WM Project Number: 18156
Our Ref: 18156 Ltr 200619

Re: Dunmore Lakes Sand Extraction Project Modification 2 - Responses to Noise Submissions

Figure 0-1 RMS Property

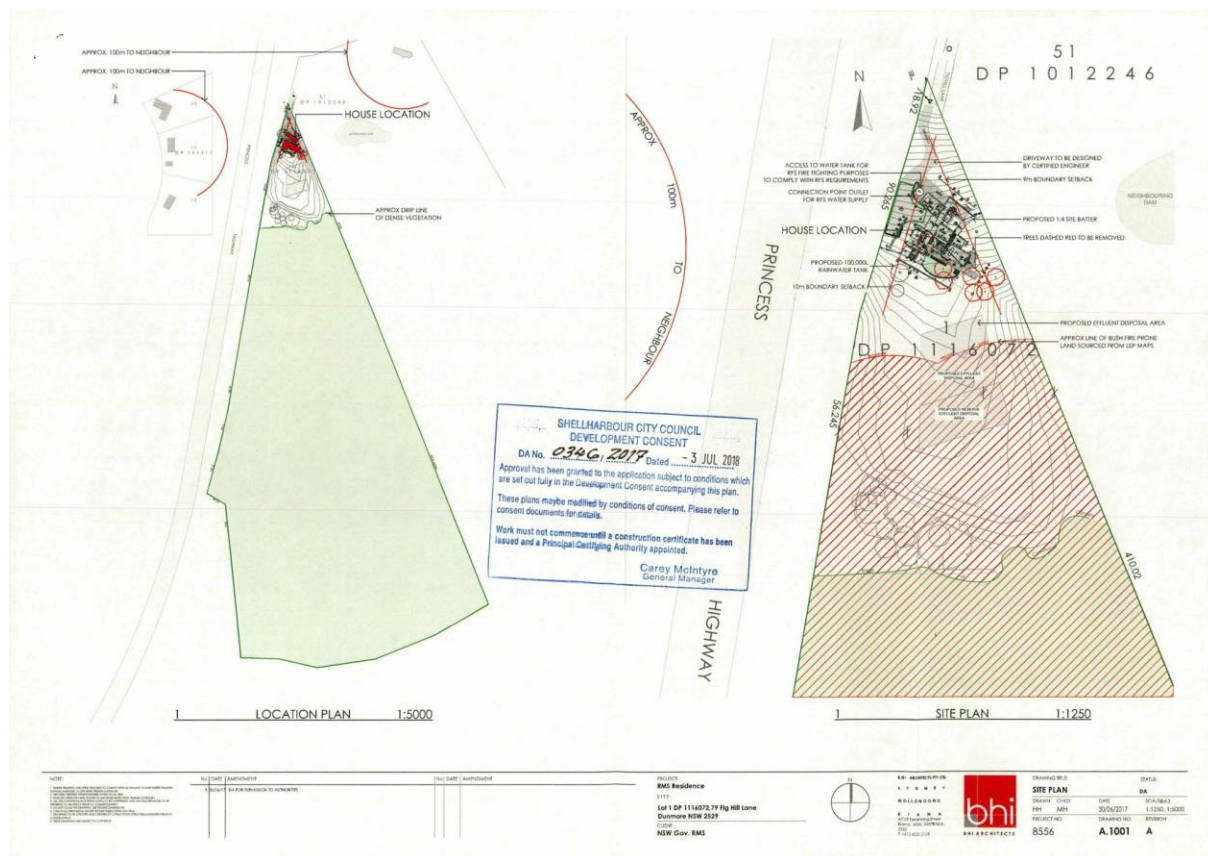
The NSW Roads and Maritime Services (RMS) has provided a submission to DP&E in a letter dated 20 May 2019. The submission notes that RMS is the owner of Lot 1 DP 1116072, known as 79 Fig Hill Lane Dunmore and that development consent has been granted by Shellharbour City Council for a new dwelling on the land.

79 Fig Hill Lane is located immediately adjacent to the Stage 5B area of the proposal, and the location of the approved dwelling is in the northern part of the property.

The predicted operational noise levels at 79 Fig Hill Lane are presented in Table 6. Noise levels have been predicted at the most affected point on or within the property boundary, but not more than 30 metres from the approved dwelling. The location of the approved dwelling is shown in Figure 0-1.

Review of Table 6 indicates that the predicted operational noise levels at 79 Fig Hill Lane generally comply with the PNTL during operations in Stage 5A, however exceed the PNTL during operations in Stage 5B. The predicted exceedances range from 5 dB to 16 dB.
